Sun Path Products Inc. 404 W Edinborough Ave. Raeford, NC 28376 (910) 875-9002

TSO LABEL ERROR

March 13, 2014

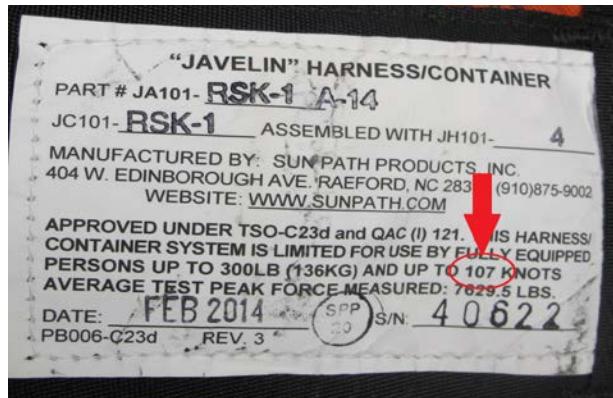
On March 13, 2014 Sun Path Products discovered that there was a typographical error on TSO labels on our harness/container systems manufactured between October 2013 and March 2014. The TSO Label should state:

APPROVED UNDER TSO-C23d AND QAC (I) 121. THIS HARNESS/CONTAINER SYSTEM IS LIMITED FOR USE BY FULLY EQUIPPED PERSONS UP TO 300LB (136KG) AND UP TO 170 KNOTS AVERAGE TEST PEAK FORCE MEASURED: 7629.5 LBS.

The original TSO wording as stated above is applicable to the harness/containers that are affected by the error.

Sun Path Products has authorized the original owner to make the following modification:

1. LOCATE THE TSO LABEL ON YOUR JAVELIN HARNESS CONTAINER SYSTEM AND VERIFY 170 KNOTS.

2. USE A FINE POINT MARKER AND DRAW A SINGLE LINE THROUGH 107 AND WRITE 170 IN ONE OF THE TWO WAYS PICTURED BELOW.
